Subject: Suggestions in regard to Master Plan/Zonal Plan of Zone G

MODIFIED ZONAL DEV PLAN  
ZONE G WEST DELHI-I

MASTER PLAN UNDER  
FINAL CONSIDERATION  
VILLAGE SAMALKA  
SUB ZONE -18  
ZONE-G

Enclosure: Suggested plan for Zone G-18

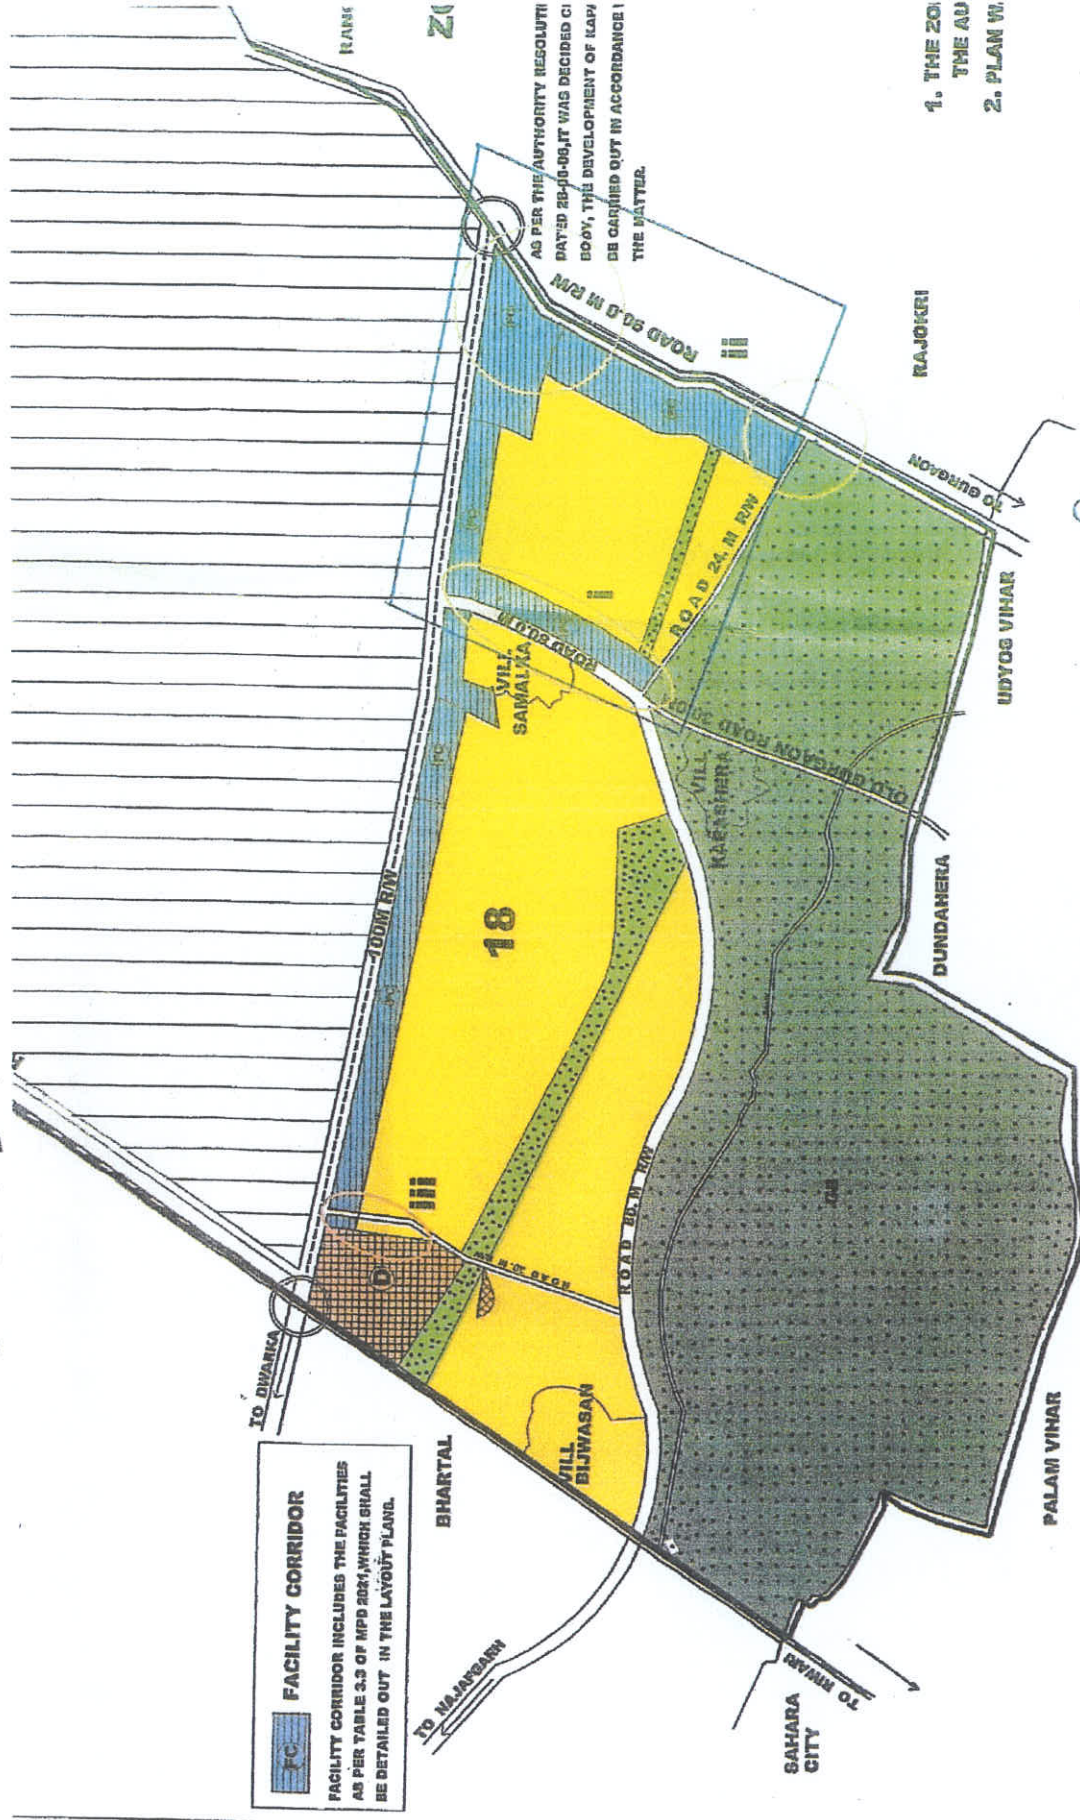
In the draft zonal plan for G-18 there is a proposed new 80m R/W road between the high tension lines extending the 80m R/W road that is between Village Bijwasan and Village Kapasehra all the way to NH-8 (90m R/W) and forming a T-junction with NH-8 and not continuing into Zone J. I would like to suggest that the proposed road is unnecessary and would be very disruptive to traffic flow in the area, particularly on NH-8 as it is meeting NH-8 very close to two nodes, one a T-junction for the 100m R/W road from NH-8 to Dwarka, and the second the beginning of the NH-8 flyover over Rajokri-Bijwasan Road. As traffic has been increasing significantly on NH-8 over the past several years, the additional intersection would be disruptive and create even greater traffic jams rather than help ease traffic. I would suggest instead to invest in clovers at the intersection of the 100m R/W Dwarka road with NH-8 and also broaden the Old Gurgaon Road through village Samalka between Kapasehra and the 100m R/W Dwarka road while creating a clover where Old Gurgaon Road meets the 100m R/W road. This would improve traffic flow on the 100m R/W Dwarka road as well as the 90m R/W NH-8.

I believe that the plan modified based on the recommendations of the Board of Hearing and Enquiry on objection/suggestion invited on the plan published on 17-12-2008 after its approval in Authority meeting held on 17-12-2008 vide item no. 87-2008 had the appropriate solution for G-18 with the commercial/residential block extending between a broadened 80m R/W Old Gurgaon Road to the West, Rajokri-Bijwasan Road to the South, a 100m R/W Dwarka Road to the North and a 90m R/W NH-8 to the East.
